STATE OF WASHINGTON
DEPARTMENT OF ECOLOGY

March 9, 2018

- **Site Name:** L & E Auto Sales
- **Site Address:** 227 Naval Ave & 2101 Burwell Pl, Bremerton, WA 98312
- **Facility/Site No.:** 14170
- **VCP Project No.:** NW2785
- **Cleanup Site No.:** 11943

Issue Presented and Opinion

FIGURE 2. Site Map
 Project Name: Burwell Place
 Location: Bremerton, Washington
 Project: ESC13-E002
 Client: Frick N Frack Holdings LLC
 Date: May 2013

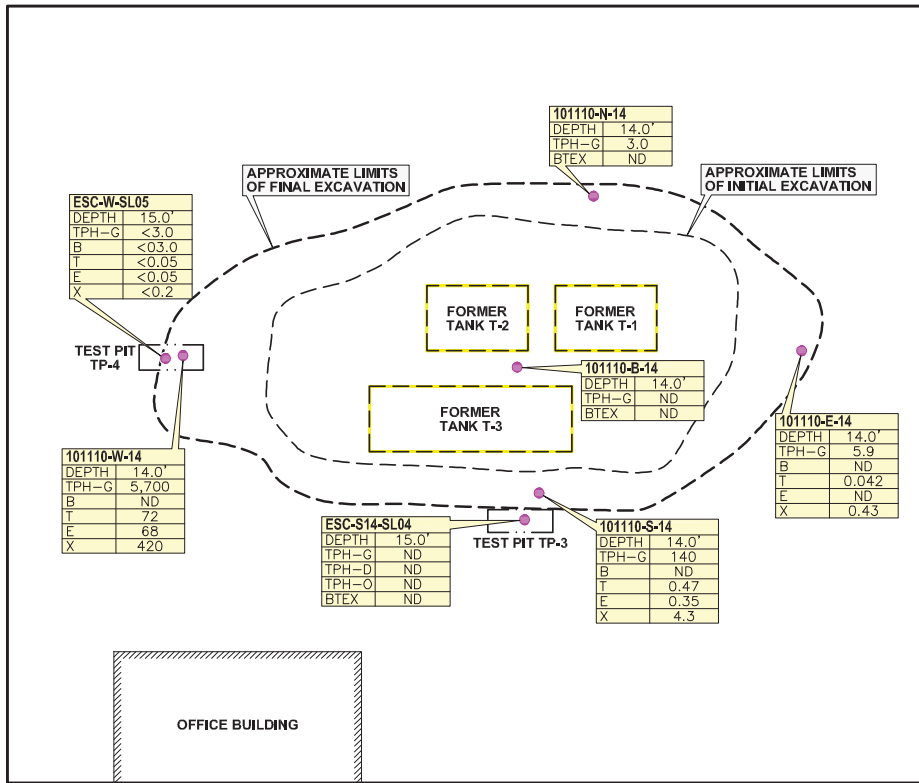
- The EnviroSound report dated July 21, 2013, Figure 2, shows that the approximate northern half of the former waste oil UST excavation area (reported by DLH to have extended to a depth of 8 feet below ground surface [bgs]) was removed during excavation of Test Pit TP-1 in February 2013. Figure 2 also indicates that TP-1 (excavated to a depth of 9 feet bgs) did not include the southern half of the former waste oil UST excavation area. In this area, DLH soil sample 81910-B-4 (collected at 8 feet bgs and 4 feet below the bottom of the tank) showed concentrations of TPHd and TPHo at 5,600 mg/kg and 13,000 mg/kg, respectively. The EnviroSound report does not state whether the soil excavated from TP-1 was disposed or placed back in the excavation.

Enclosure A, Figure 3

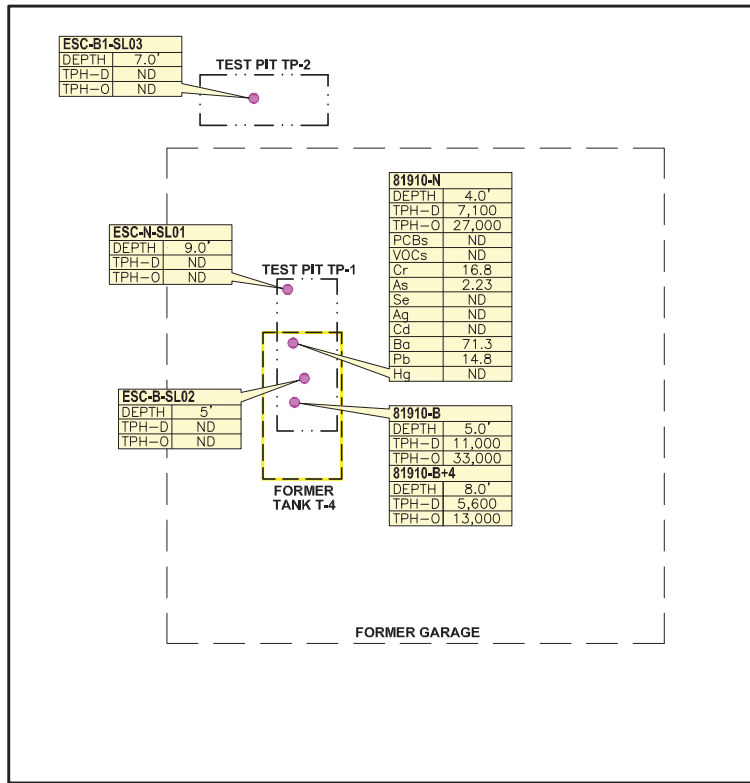
- Additional soil sampling is necessary in the vicinity of the former gasoline UST excavation to assess the extent of TPHg impacts to soil at the following DLH sample locations (see **Enclosure A, Figure 3**):
 - 82010-T1-B, center of former UST T1; vertical impacts at and below 14 feet bgs
 - 82010-T2-B4, center of former UST T2; vertical impacts at and below 14 feet bgs
 - 82310-T3-W9, immediately west of former UST T3; horizontal and vertical impacts at and below 6 feet bgs
 - 82310-T3-S10, immediately south of former UST T3; horizontal and vertical impacts at and below 6 feet bgs
- The following waste oil tank issues require resolution:
 - The DLH report dated January 12, 2011, page 5, paragraph 1, states that no soils were removed from in and around the waste oil UST. This implies that soils

- Soil sampling is necessary in the vicinity of the former waste oil UST to assess the following:
 - The presence of TPHd and TPHo in soils used to backfill the former waste oil UST removal excavation and the former TP-1 excavation.

- The vertical extent of TPHd and TPHo impacts at the 81910-B-4 location.
- Enter additional Site sampling data into the Ecology Environmental Information Management (EIM) database.
